KCH PINS procedure

Engagement with NATS, 5 July 2023

From: [REDACTED]
Subject: Kings College Hospital, London - Airspace Change Proposal - Reply Requested
Date: 15 January 2024 at 12:44
To: ACP-KCH ACP-KCH@specialist-aviation.com

RE: ACP-2023-027 Kings College Hospital (KCH) –
Provision of PinS Instrument Approach and Departure Procedures

From: [REDACTED]
Sent: 14 March 2024 19:34
To: [REDACTED]
Cc: [REDACTED]
Subject: Kings PinS Revised Missed Approach Procedure - Option

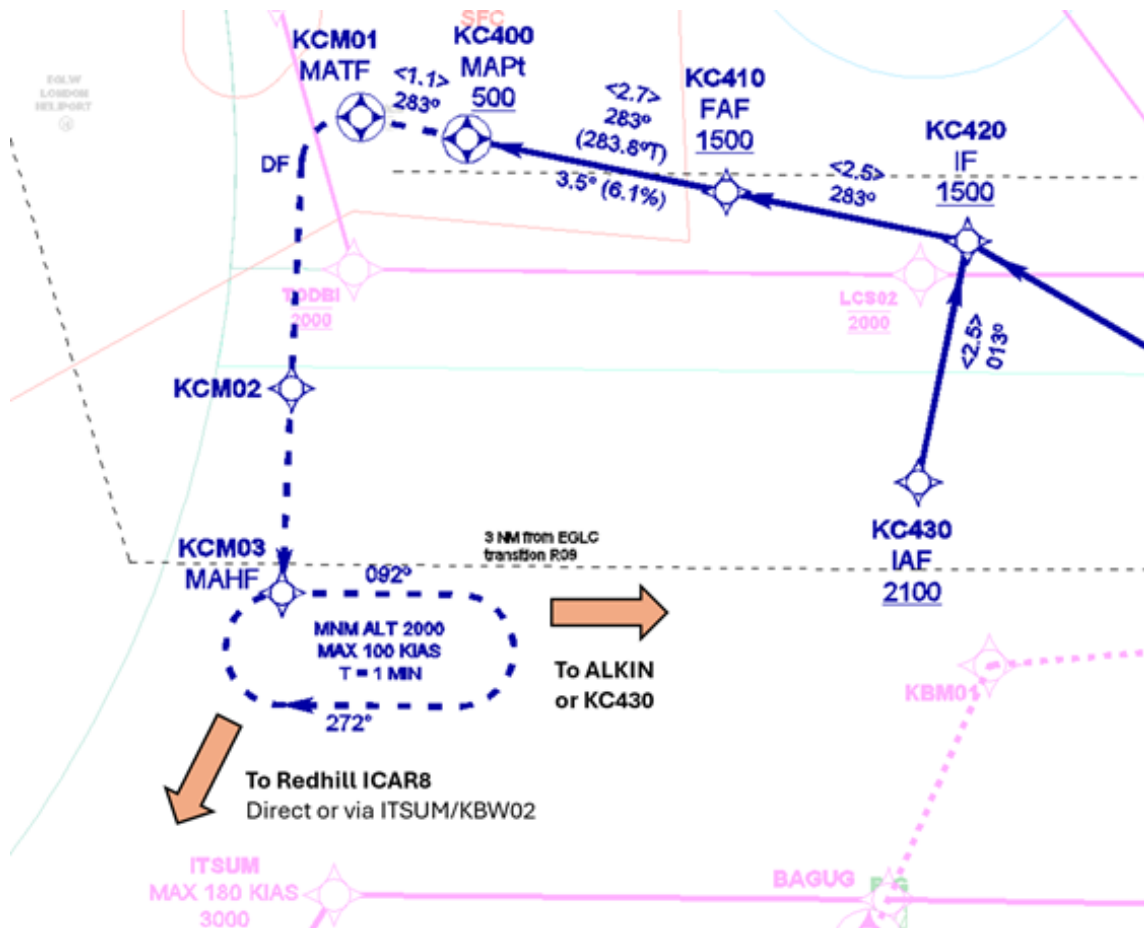
Now, I know I said it would be very unlikely that we would need to use the missed approach procedure, I imagine that there may still be a requirement for it to be taken into account – which, as you pointed out, would require a bigger window for one of our approaches into Kings.

Have a look at the above, and see what you think.

This alternative gets us further south, more quickly than the previous preferred option, we can hold clear of the 09 inbound and below Biggin's RNP03 traffic. When cleared, we could route in for another approach into Kings via KC430, easily divert east for ALKIN and Rochester or head southwest for a 07 join into Redhill. This looks like a very elegant set of options to me.

apparent that we couldn't hold the aircraft at a low enough altitude to deconflict with the 09 inbounds due to the Crystal Palace masts – which is exactly as you thought, I just wanted to confirm that this option was examined too.

Given the feedback we've also had from Biggin, it would make sense to change the missed approach procedure to the revised option as described.

This would at least reduce some of the impact on the existing 09 operations. Given the usage split, we're looking at a likely maximum of 9 interruptions (of c.10 minutes) in peak periods over a 12 month period.
